CALL NO. 112  
CONTRACT ID NO. 232954  
ADDENDUM # 2

Subject: Trimble County, FBP 4201(088)  
Letting November 16, 2023

(1) Revised/Added - Special Notes - Pages 20, 36a-36b, 58-62 of 159

**KENTUCKY TRANSPORTATION CABINET  
DEPARTMENT OF HIGHWAYS  
BRIDGE REHABILITATION PLANS  
ITEM NO. 5-10107**

## SPECIAL NOTE FOR JOINT SEAL REPLACEMENT

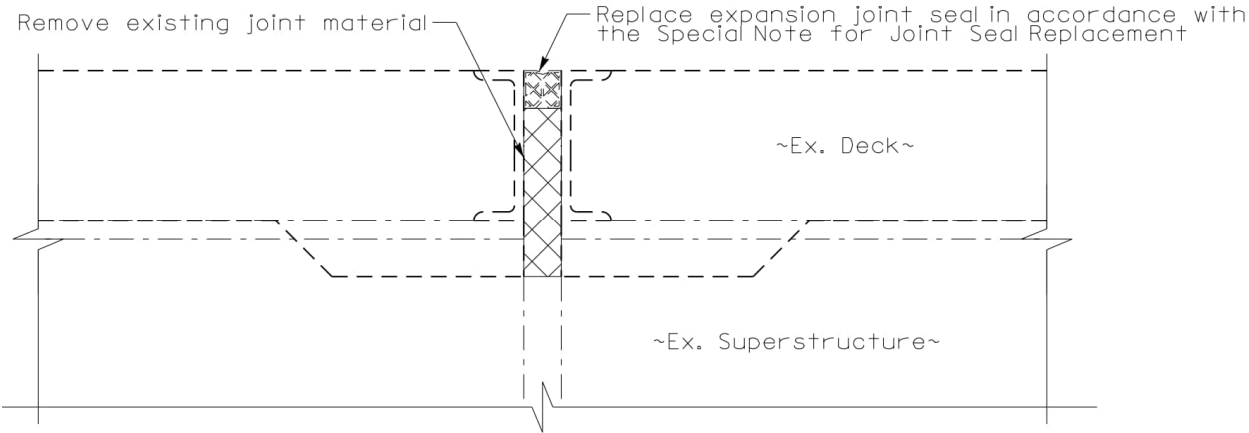
**B. Joint Seal.** Seal shall be installed in accordance with manufacturer's recommendations concerning approved adhesives, welds between sticks and appurtenances, and adhesion to concrete deck or armored edges. Joint seal is to be installed 1/2" recessed from the surface.
